October 28, 2011

RE: Creekside Memorial Park Cemetery Draft Environmental Impact Report (State Clearinghouse Number 2007012069, County File No. LP052096)

Figure 3. The Site Plan for the Project includes an access road and upper garden which divide the site in half, fragmenting habitat for special status species.

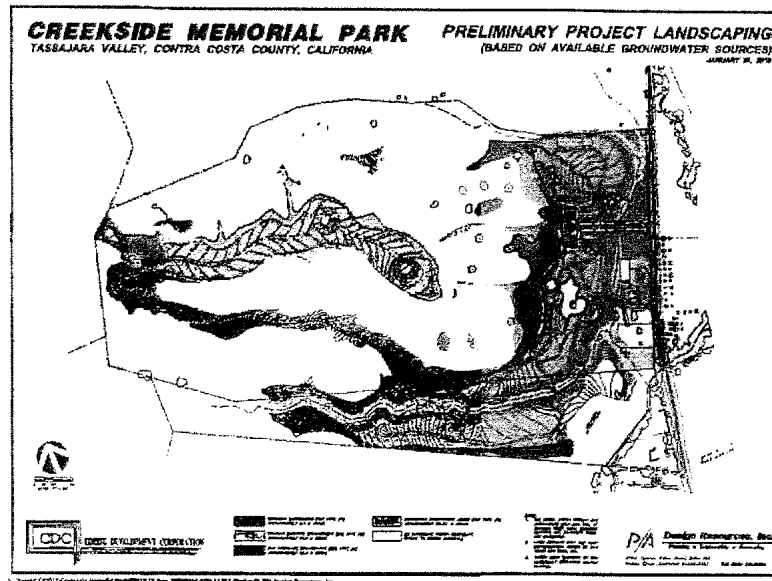
- 2) **Fragmentation of Open Space and Mitigation Land**
Our most significant concern is with the upper garden and its access road; we believe that the proposed upper garden area should be eliminated from the project. The access road to the proposed upper garden area (including a short spur maintenance road to the water tank) bisects the property and fragment proposed mitigation habitat at the site. It effectively cuts the property into two pieces. This limits the connectivity between the two halves at least for some species which, under existing conditions, travel freely through and around the property. This loss of connectivity is a potentially significant environmental impact on federally listed California red-legged frog (CRLF) and California tiger salamander (CTS), both of which have been documented in the two ponds located on opposite sides of the property (see Figure 3). The Project is within the area designated as Critical Habitat for CRLF. The dEIR does not propose mitigation for this impact, which could be avoided by eliminating the upper garden, as in the Smaller Project alternative discussed in the dEIR or by other modifications, such as realigning the road or moving the upper garden to one side of the Project site or the other. Current mitigation is not adequate to fully compensate for this impact. The dEIR should be revised to evaluate the impact of habitat fragmentation on these species and to include mitigation addressing it.

As mentioned in our summary comments, among the most significant impacts from the Project on animal species is the fragmentation of habitat. The upper garden area and the road providing access to it effectively cut the property into two pieces. For example, this is especially significant in terms of the habitat provided for CRLF and CTS; the loss of connectivity between the two ponds isolates these two populations, which makes each population more vulnerable to local extinction from problems such as those related to disease or in-breeding. The dEIR lacks adequate discussion of the Project's long-term impacts on these special status amphibians as a result of habitat fragmentation.

Figure 4. Conceptual Planting Plan for the riparian corridors.

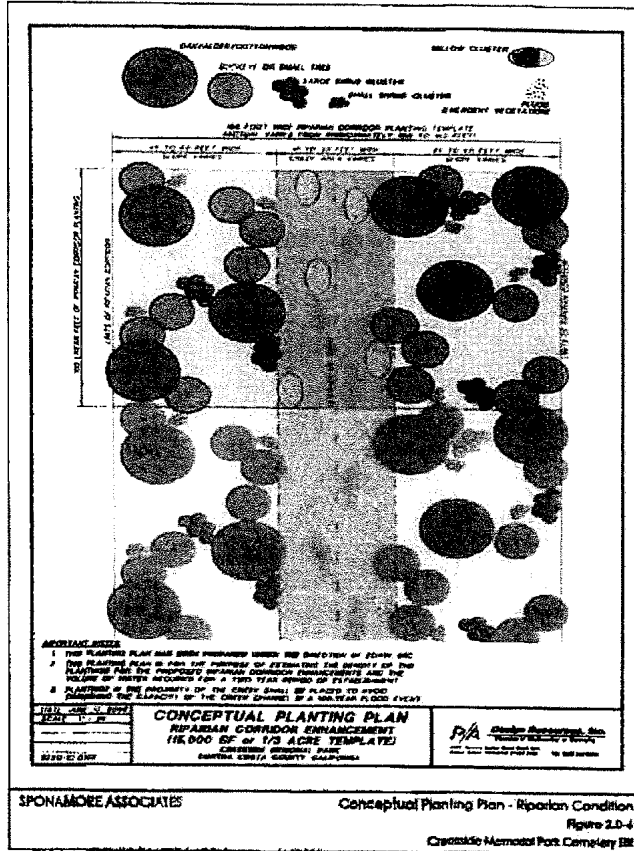
We are concerned that the Conceptual Landscape Plan, which include oak woodland and riparian enhancement plans calls for planting more trees than the site would naturally support if the conceptual planting plans shown in the dEIR Figures 2.0-6 and 2.0-7 (included here as Figures 4 and 5) are an accurate representation of what will be constructed. Large numbers of trees are not appropriate in grassland ecosystems and not all riparian corridors support an extensive populations of trees (even native cottonwoods, buckeye, or oaks), particularly small seasonal drainages in areas with conditions like those found in Tassajara Valley. In subsequent chapters of the dEIR, this particular component of the Project is identified as a potentially significant adverse impact on the existing grassland habitat. The dEIR also includes a mitigation measure eliminating the enhancement plan from the Project's Conceptual Landscape Plan (dEIR page 3.4-45 and mitigation measure 3.42d).

With specific respect to the riparian areas at the Project site, it must be noted that not all riparian zones support significant numbers of trees. Plantings in this area should be done in close consultation with a qualified botanist/ecologist. Enhancement of the seasonal creeks does not need to rely on planting trees; habitat enhancement could be achieved through a variety of other measures (in addition to some planting): restoring the banks of the creeks making them more stable, excluding cattle from the creek area, etc. Also, as mentioned previously, it is unclear at this point whether or to what extent an enhancement plan will be part of the Project.

reflect a habitat enhancement plan that is more appropriate for the habitat types currently existing at the site. The dEIR should be revised to reflect this change and mitigations included to clarify that grassland will not be landscaped.

Figure 5. Conceptual Planting Plan for oak woodland enhancements.

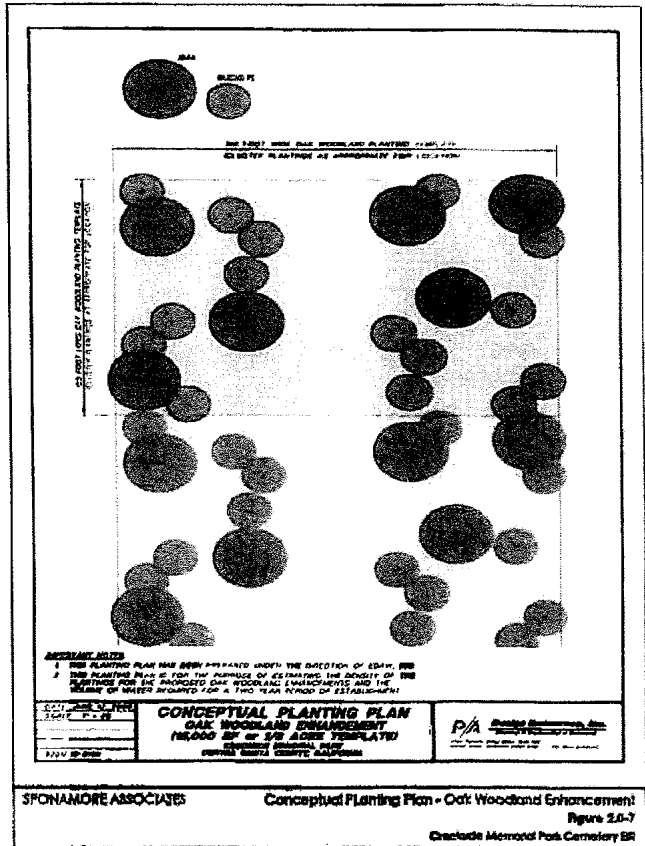
The Project includes a riparian and oak woodland "enhancement" component that would include planting numerous trees on the hillsides above the lower garden. As described above, the Tassajara Valley, under natural conditions, would be native grassland with some oak savanna; would not support large numbers of trees such as those depicted in the photo simulations Figures 3.1-3, 3.1-5, and 3.1-7 of the dEIR. This would substantially alter the existing visual qualities of the site, which currently mimic its natural condition. We suggest that the Project should be revised, such that only limited planting of native tree species is included where necessary for screening. Again, as mentioned above, in addition to maintaining the existing visual qualities and native grassland habitat, a revised planting plan would also demand less water.

Figure 6. Hidden Valley Open Space's Tassajara Ridge Trail and its proximity to the proposed Creekside Memorial Park Cemetery water tank and upper garden. The proposed New Farm project is also shown.

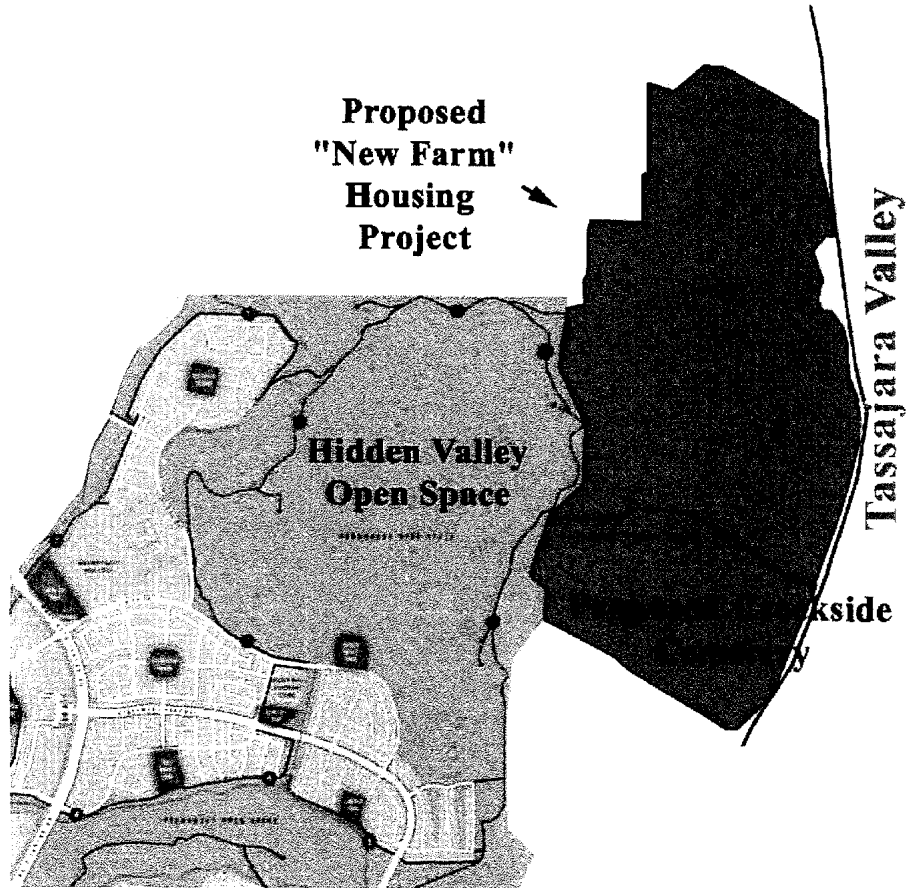
The Project is adjacent to Hidden Valley Open Space (HVOS) on the west (the side of the property opposite Camino Tassajara Road). The Tassajara Ridge Regional Trail, a well-used trail is at the boundary between HVOS and the Project site (see Figure 6). Users of the trail would have a clear view of the newly constructed cemetery, particularly the water tank proposed for a location adjacent to the boundary that will be installed to provide water for the irrigation, fire, and the rest of the facilities.

We believe the tank should be moved away from the fence and trail. We support the proposed mitigation measures for this impact which include placing the tank below grade, painting it in a color that blends with the environment, and providing screening through plantings of native shrubs and/or trees (dEIR, mitigation measures 3.1-1 and 3.1-2). In meetings with the Applicant and his representative, they indicated that they are open to moving the tank further from the fence along with other mitigation measures already offered.

Figure 7. Important Agricultural Lands in the Tassajara Valley, include the proposed Creekside Memorial Park and "New Farm."

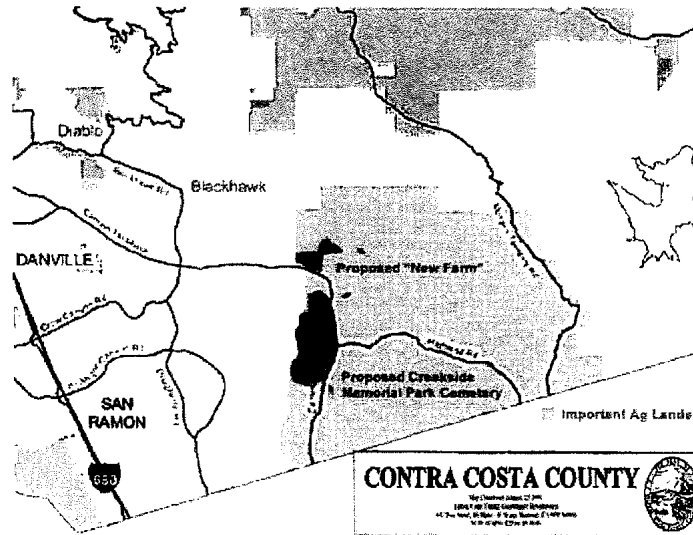
As the dEIR points out, the Tassajara Valley is considered of local importance for agriculture as indicated on County maps (see Figure 7). The general area, including the Project site, is primarily used for cattle grazing operations. The Project will convert 58.7 acres from existing agricultural uses for the purposes of the cemetery and supporting facilities. This conversion contributes to the overall decline and fragmentation of agriculture in the Tassajara Valley, particularly when considered in light of other proposed development in the area, such as the "New Farm" project, adjacent to this project on the north.

The discussion of impacts to agriculture in the dEIR dismisses the potential for any cumulative effects from the Project and gives this a rating of "no impact" after a three-sentence description. This is insufficient. The dEIR should be revised to provide a more thorough analysis the potential cumulative impacts in the Tassajara Valley, particularly given the proximity to other projects and the regions status as "important agricultural land."
